## MEMORANDUM

RE: **May 31, 2016**, meeting of the University Facilities Planning Board to be held in the **Facilities Meeting Quonset** at **3:30 pm**

<b>ITEM # 4</b>	<b>Zahner/School of Art Sculpture Proposal</b>
-----------------	--

# SCHOOL OF ARCHITECTURE + A. ZAHNER COMPANY COLLABORATIVE DESIGN PROJECT

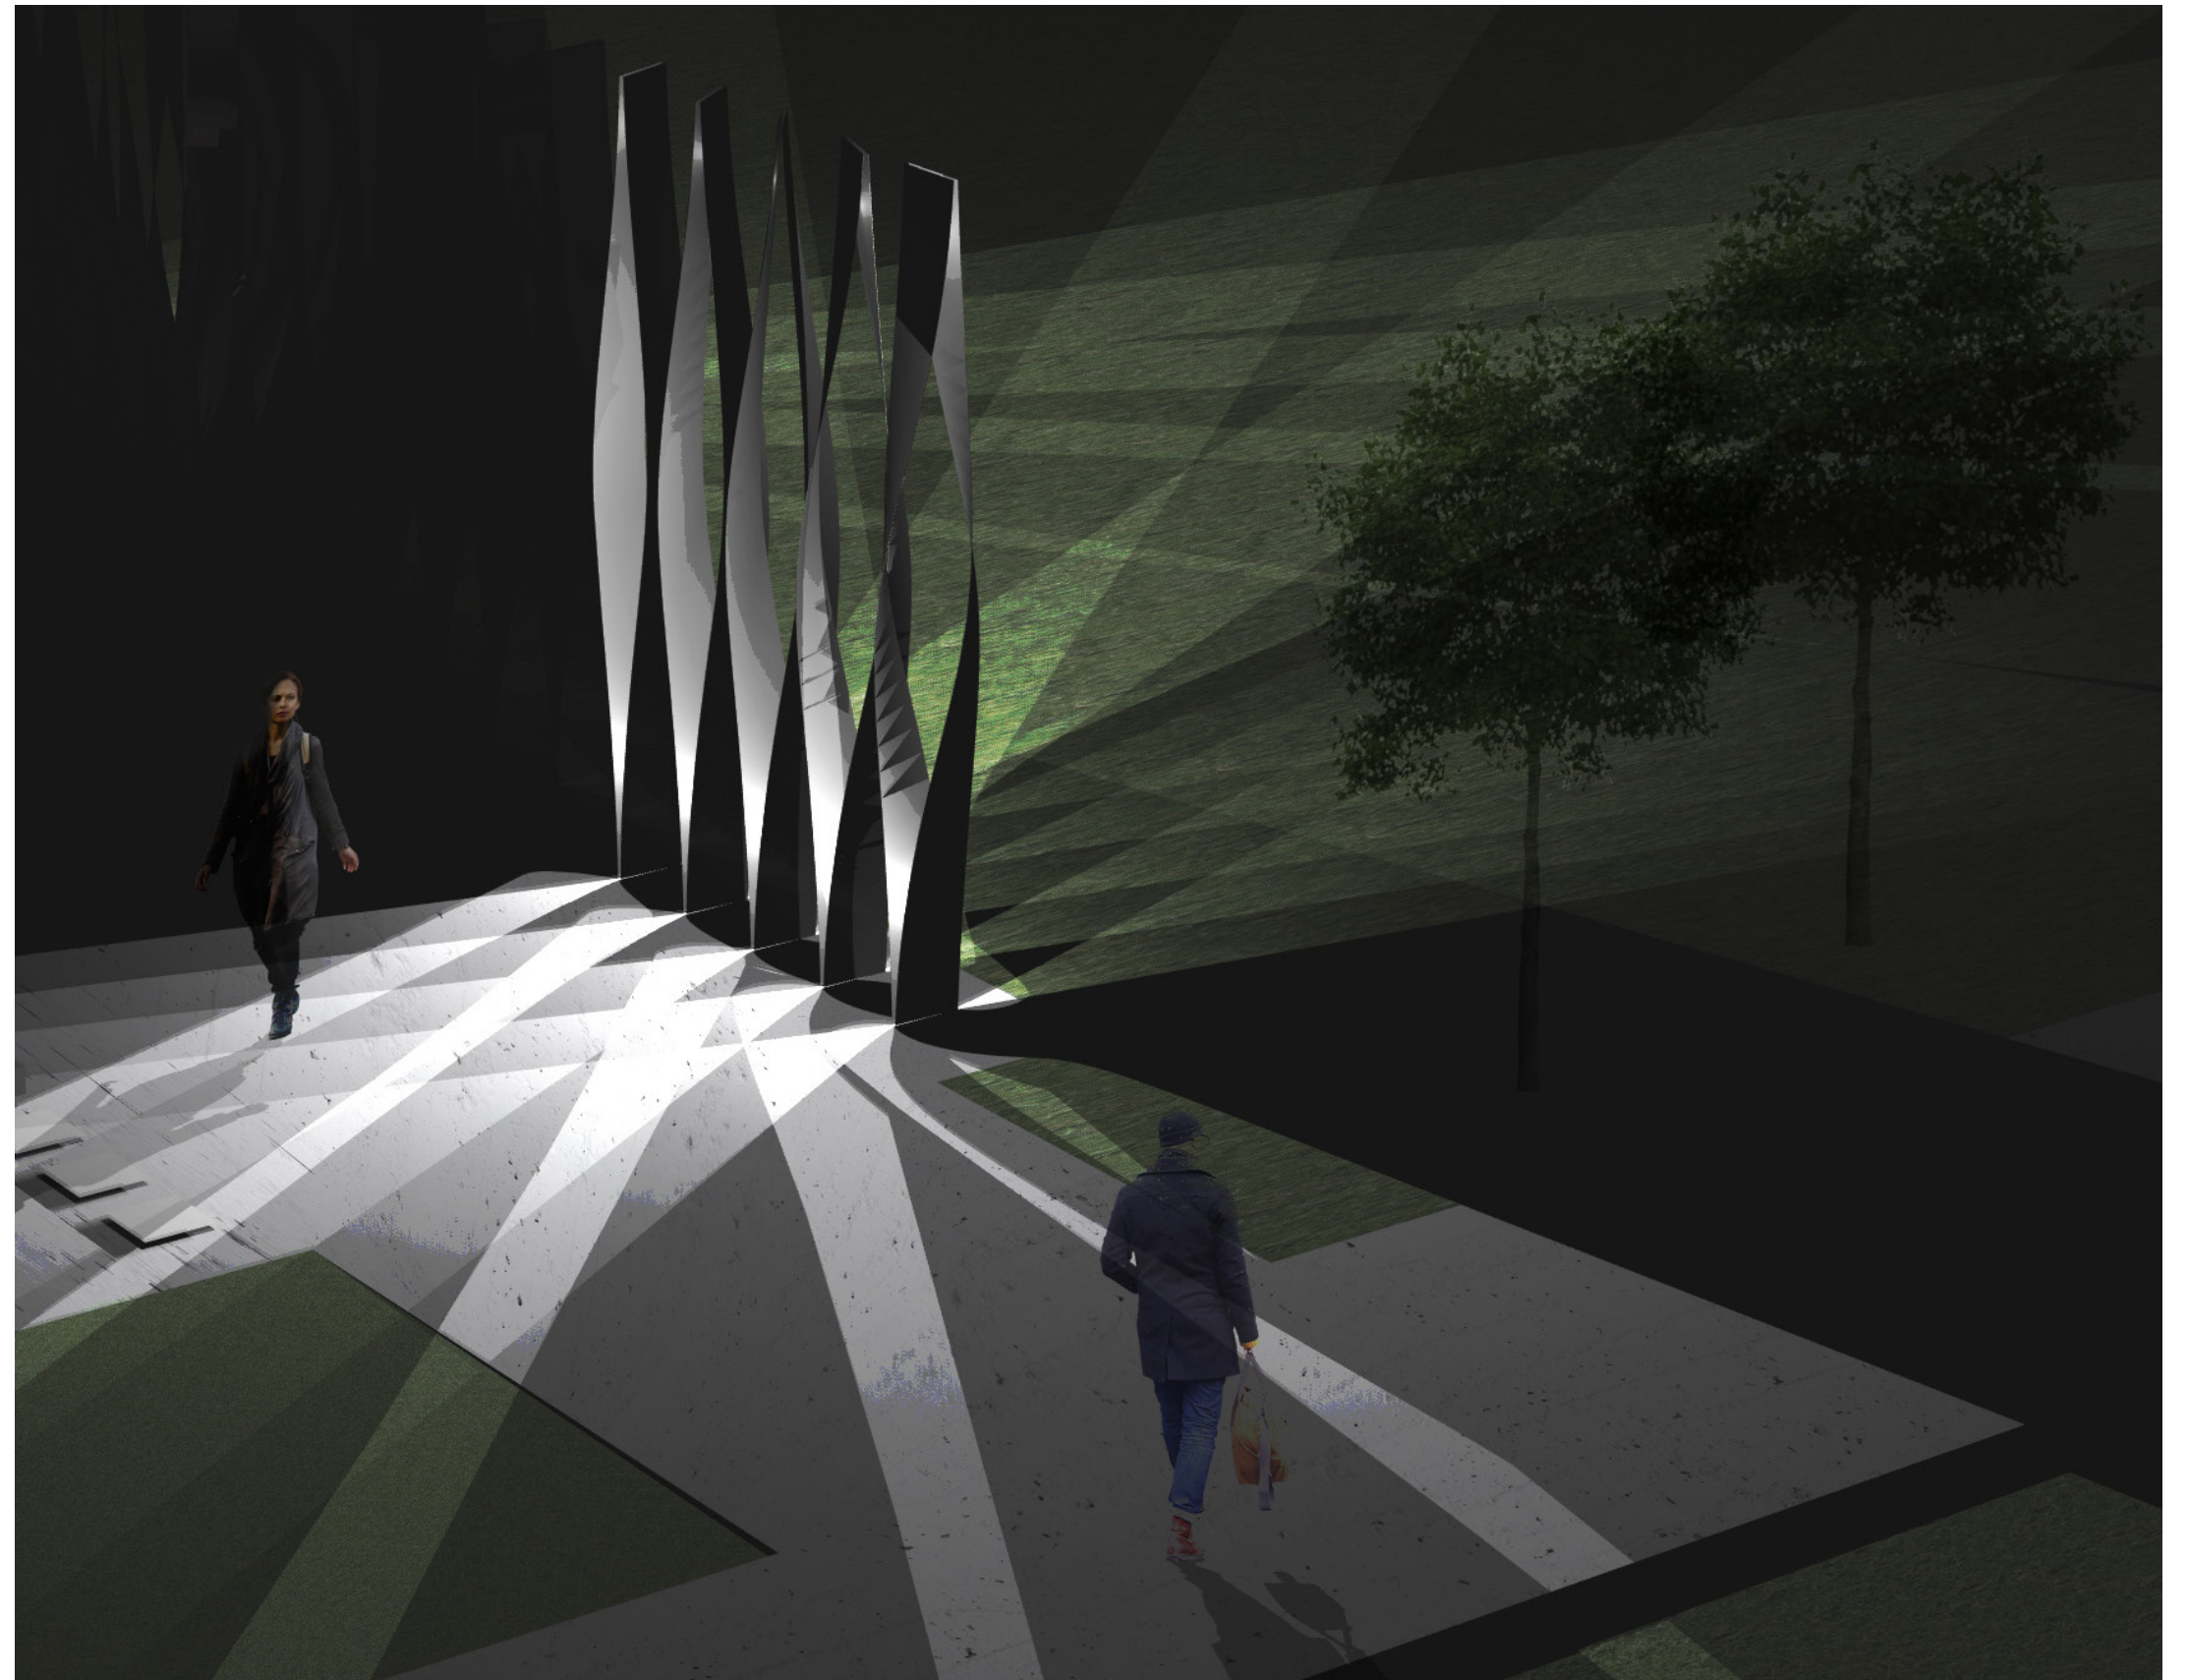
1. **Siting the sculpture:** According to the Public Art Policy, an art gift does not include a specified site for its installation. This proposal does include a site. The PAC and Pre UFPB reviews support the general vicinity as proposed. However, it will be very close to the Arc Flight (aka Snow Plow) by Jeff Boshart that has been on the campus since 1978 and relocated to its current location in 2014 to create a site for The Lift Tower Project sculpture. If the Arc Flight is relocated – then PAC/UFPB would need to review potential relocation sites, the cost and funding for the relocation.

2. **Lighting:** The project team/students will evaluate the lighting component since most of the university's public art does not include lighting. LED is preferred for energy efficiency and bulb longevity. With upward oriented lighting, the potential impacts to the night-sky need to be reviewed by MSU Faculty, Joe Shaw for design mitigation and prevention of unintended consequence of lighting the sculpture. And Facilities Services needs to evaluate the proposed removal of two existing light poles.

3. **Snow removal:** Currently snow removed from the vicinity is moved via the sidewalk perpendicular to the sculpture's proposed location. FS Environmental Services Manager needs to evaluate impacts and possibly change some snow removal routes. If the proposed location of the ~50ft long sculpture is moved further west of the intersecting sidewalk, then it would be into the trees and shadows of Cheever Hall.

4. **Protection:** The project team/students need to evaluate including a concrete curb around the stainless steel base of the sculpture to prevent damage from snow removal and lawn moving equipment. In addition to the curb - consider paving the ~2ft perimeter of the sculpture base to create a separation from turf, irrigation sprinklers, and walkways.

5. **Safety:** The project team/students must provide installation drawings and specifications approved by a structural engineer to be used for the installation.

6. **Rock Infill:** The project team/students need to resolve how the gravel infilled base of the sculpture will be contained in the base – and not picked out.

7. **Facilities Services/CPDC Coordination:** As part of the installation and planning for future maintenance of the sculpture, the project team/students need to coordinate with FS/CPDC regarding site preparation including relocation of utilities; sculpture installation including schedule and contractor coordination; and specifications for ongoing maintenance needs.

Condition 1. The public art gift to MSU includes funds to cover all installation expenses (could be +/- \$30,000 and FS/CPDC must supervise all campus construction done by FS or contractors).

Condition 2. Approval by Facilities Services/CPDC and coordination of installation, including participation with project team/students to inform evolving design changes affecting the dimensions of the sculpture, utilities, site improvements, and location.

Condition 3. Installation drawings approved by a structural engineer (expense included in Condition 1) and timely in the process in order to meet the team’s installation schedule.
